(Cover Letter for Dominic Vecchione Letter, Submitted by Joanne Cullinane, precinct 21)

I am providing comments to the plans submitted for the property at 126 Broadway, Arlington MA.

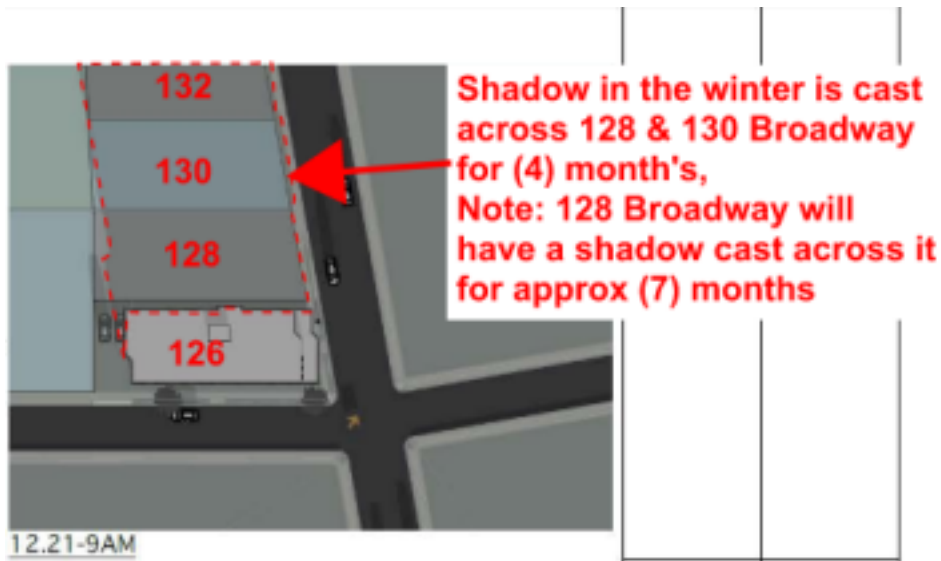
The Shadow study (below) does not properly show that there is an impact to the property at

128, 130 & 132 during the winter for (4) months +/- and that the property at 128 Broadway

will have a shadow cast on it for approx. (7) months a year. A project should not have such a

Large impact on its adjacent neighbors.

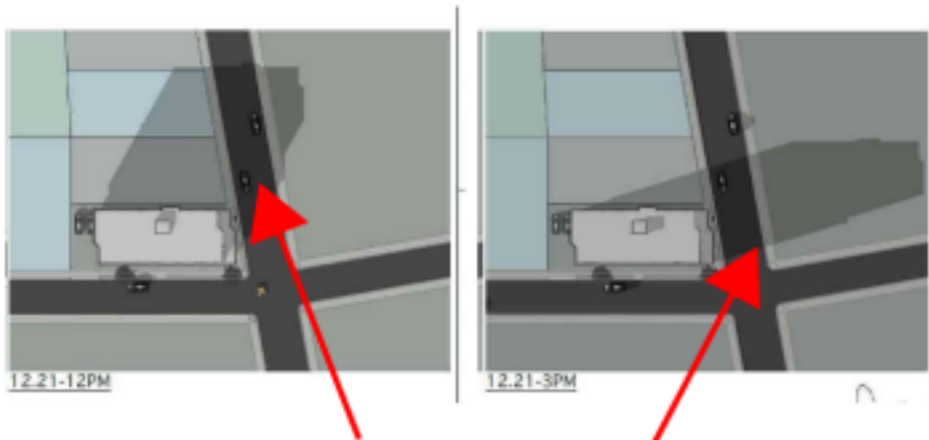
The

Shadow study(below) and the perspective (above) do not meet the Town of Arlington

Design guidelines for commercial Corridor, this will create a Canyon effect and is not

inviting at the street
